Addendum

Date of Letting: March 19, 2013 Date of Addendum: March 6, 2013

B.O.	Proposal ID	Proposal Work Type	County	Project Number	Addendum
108	91-0352-336	PCC PAVEMENT -	WARREN	BRFIM-035-2(276)6505-91	19MAR108.A02
		GRADE AND NEW		IMN-035-2(332)650E-91	
				IMN-035-2(333)650E-91	
				IM-035-2(336)6513-91	
				BRFIM-035-2(356)6305-91	
				IM-035-2(357)6313-91

Plan Sheet C.3:

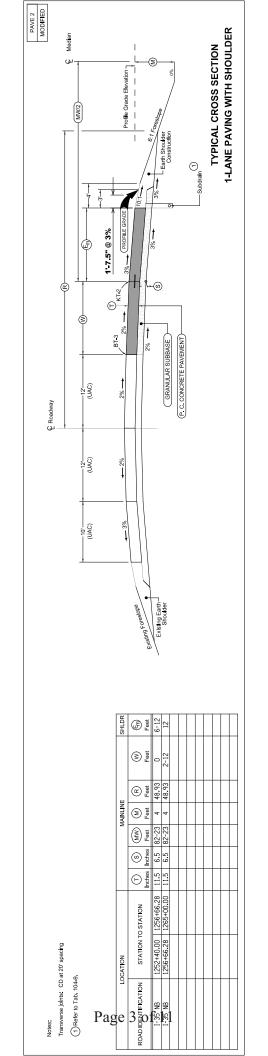
For Item Code 2102-2710070 EXCAVATION, CLASS 10, ROADWAY AND BORROW, delete the fourth paragraph that states:

Borrow includes 260,406 cu. yds. select clay.
